FMC234 Product Change Notifications

2024.09.10: PCB changes

2024.01.22: Modified battery placement within the casing

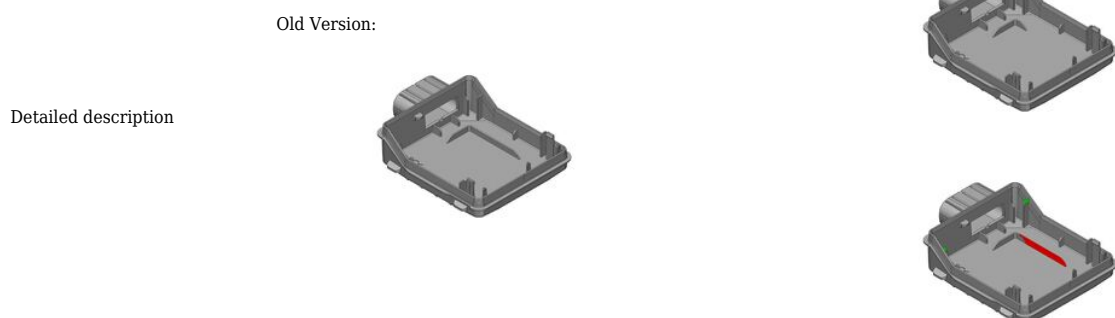
We would like to inform you that starting from January 2024, there will be a small change in the FMC234 devices casing. We have adjusted the battery placement and increased PCB guide height within casing. This modification was essential to enhance our manufacturing process.

Change description	Optimizing robotic battery placement process within casing	
Change type	The modifications will not impact the place of the battery or PCB within the FMC234 device.	
	New Version:

Change reasons
1. Modified battery placement within the casing.
2. PCB guide height increased for easier assembly.
3. Improved manufacturing process.
